Our Case Number: ABP-316272-23

Re: Bus Connects Templeogue/Rathfarnham to City Centre Core Bus Corridor Scheme
Templeogue/Rathfarnham to City Centre

**BusConnects Templeogue / Rathfarnham to City Centre CBC
Objection to proposed Compulsory Purchase Order - 11 Rathfarnham Wood,
Rathfarnham, Dublin 14 - Plot List: 1019(1).1d, 1019(2).2d
Submission on (1) Planning Application in respect of and (2) Proposed CPO of
Woodland area of Rathfarnham Castle Park – Plot List: 1001(1).1f; 1001(2).2f**

**BusConnects Dublin Templeogue / Rathfarnham to City Centre CBC
Submission on Planning Application in relation to the Proposed Scheme
Objection to proposed Compulsory Purchase Orders
Rathfarnham Castle Park
Entrance to Rathfarnham Wood Estate**

Close up view of Fig 13.1 – Surfacewater study area – showing no watercourse marked beside RCP although it is an open watercourse just inside the RCP wall where it will be directly built over. This is despite the fact that the maps at Fig 14.5 and Fig 14.13 clearly show the Glin River and duck pond.

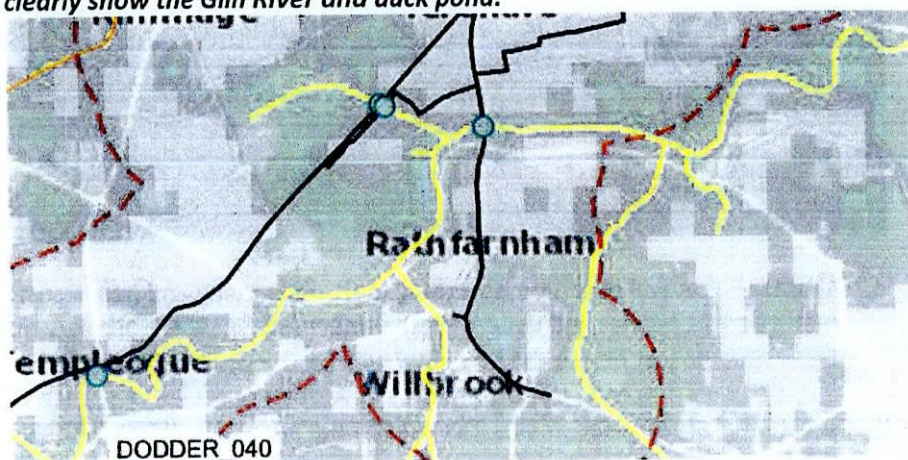
Yet when it comes to the actual environmental study areas, the Glin River and duck pond are not included. They have clearly not been evaluated or even considered. We cannot understand this glaring omission and clear breach of the Water Framework Directive.

Image 2.14 from Chapter 2 of the EIAR showing minimal impact from Grange Road to Rathfarnham Road / Fergus Road:

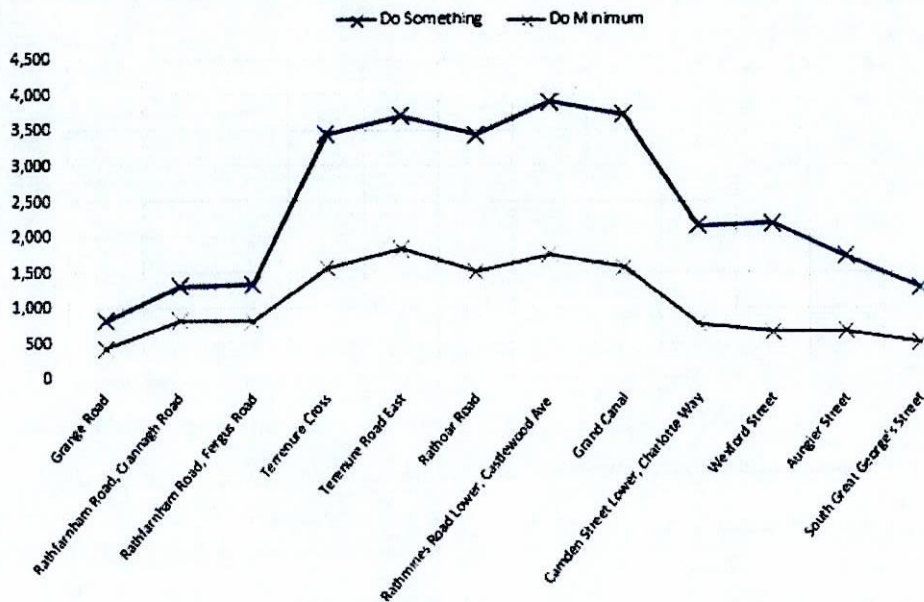
The projections show that the proposed reductions in journey time due to BusConnects will be minimal. Image 2.14 in Chapter 2 of the EIAR shows that the BusConnects scheme would have a far lesser impact around Rathfarnham than it would at other areas in any event.

Fig 12.1.3. - Ecological Study Areas: Aquatic and Riparian Survey Site:

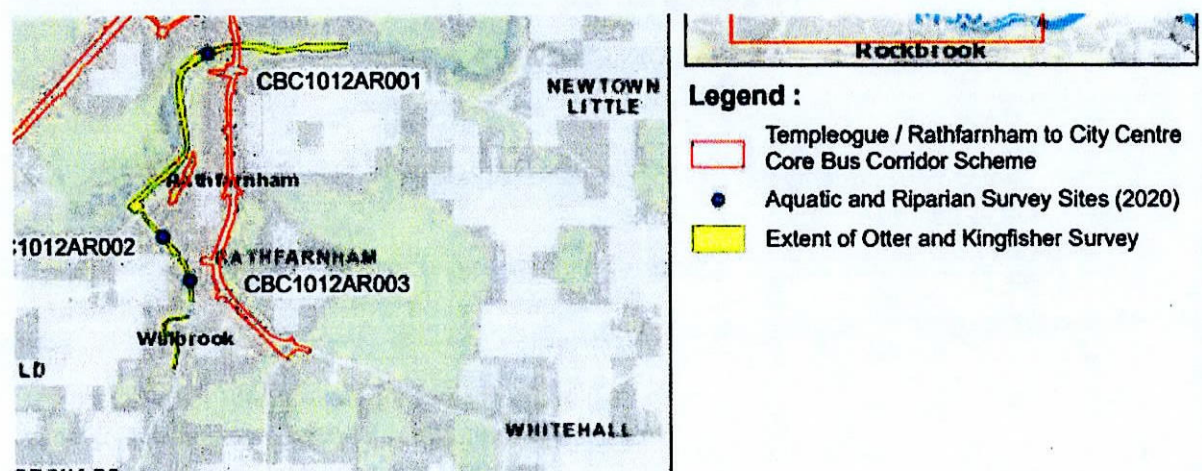
It is clear that neither the Glin River nor the pond were surveyed for otters or kingfishers. This is despite the fact that a kingfisher has been spotted in the Park, most recently on 23/7/23 and the Glin River / Whitechurch Stream is a known otter habitat.

Image 07 in Appendix 14.1 notes the presence of an apparently “dry” stream close to Butterfield Avenue (it is an active watercourse) yet completely fails to consider that there is a pond in the Park and a water source, the River Glin, constantly feeding and draining that pond!

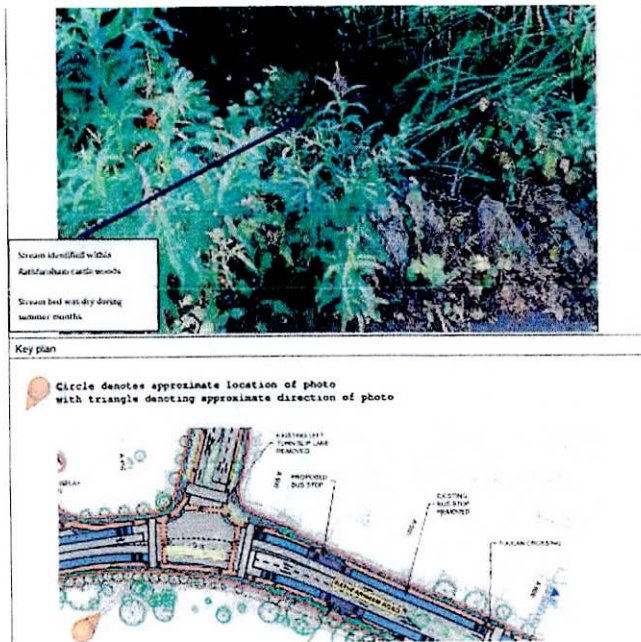
However it can be seen from the above table that the only stream in RCP identified in this survey was thought to be running “adjacent to the proposed bus corridor”, not actually under the corridor at two locations. See below indicator from Image 07 of where the photo was taken, close to Butterfield Avenue:

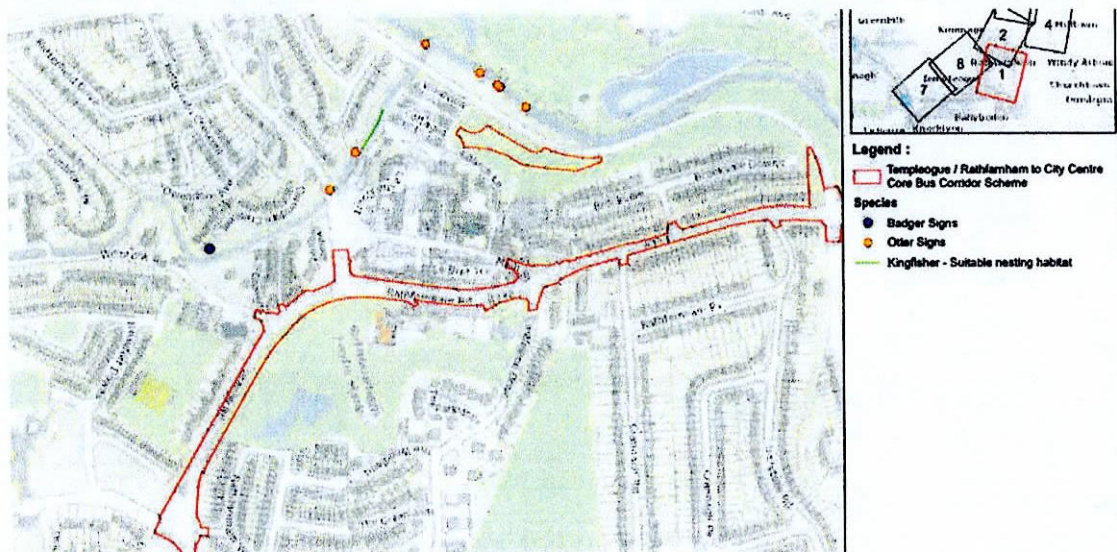
Fig 12.9 - Mammal, Aquatic and Riparian Survey Results - Note that otter and badger signs were found in the nearby area, yet RCP, a particularly important wildlife habitat with an active watercourse and a pond rich in aquatic life, wasn't even surveyed. Note also that RCP was not surveyed as a suitable kingfisher nesting habitat, although a kingfisher has been seen very recently:

Time after time, Rathfarnham Castle Park and its flora and fauna and hydrological ecosystems have simply not been properly considered at all, throughout the Scheme's environmental assessments. The environmental assessments are patently inadequate and insufficient.

Vol 1 – General Arrangement Drawings (pg. 6) – all trees marked in green, regardless of whether they are to be retained or not – highly misleading:

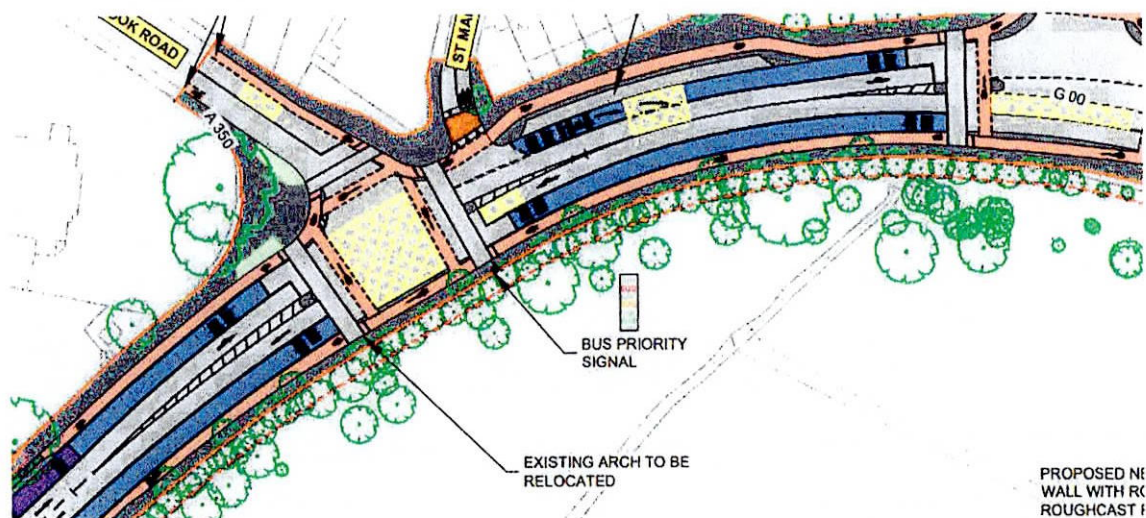
The same approach is taken in many of the maps (e.g. Vol 1 – General Arrangement Drawings), which mark all trees in green, regardless of whether they will need to be removed or not, making it very difficult to ascertain from this document exactly how many mature trees will be lost. This is contrary to the usual approach of clearly marking in red which individual trees will be lost.

The General Arrangement maps also do not give a true picture of the amount of land to be taken for road widening, instead indicating a far smaller area. The overall approach means that citizens reviewing these documents would not readily get a fair understanding of the reality of the changes
